Subject: Black & Williams Cornice

Subject: RE: Black & Williams Center Cornice Replacement

Subject: RE: Black & Williams Roof Area 3 Deck Replacement

Subject: RE: Black & Williams

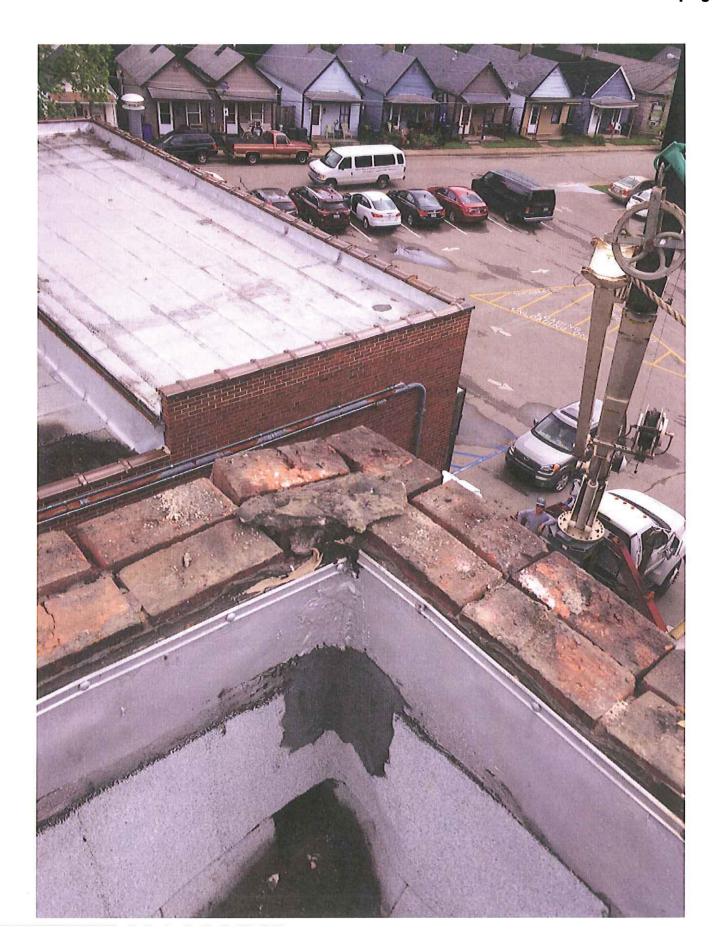
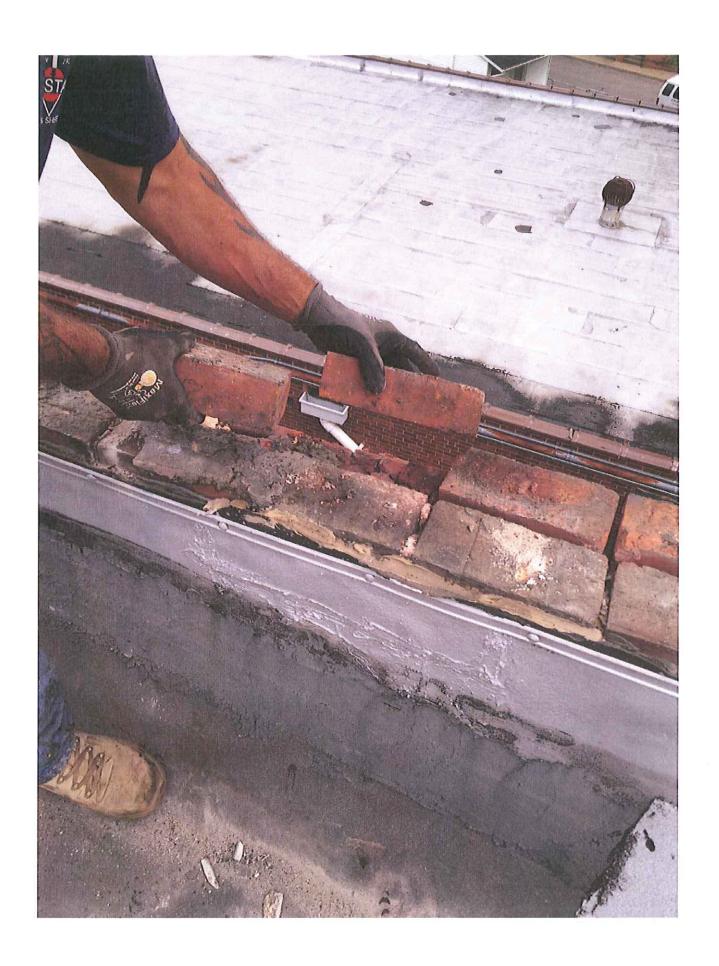
Per the email regarding the deteriorated parapet wall brick condition, Gilpin Masonry has provided the following change order to make repairs...

• To an estimated 45' of wall, we will remove and reset two wythes of brick approximately three courses deep. The brick will be removed from the wall, cleaned of all old mortar and reset with matching mortar as previously submitted. Change Order ADD price: \$3,340.00

Attached are two pictures of brick condition on a section of parapet walls on Roof Area 1. There is little to no mortar around many of the bricks in the pictures.

I recommend approval of the proposal to stabilize the top (3) courses of the 2 wythe brick wall as proposed for an increase cost in the amount of \$3,340.00
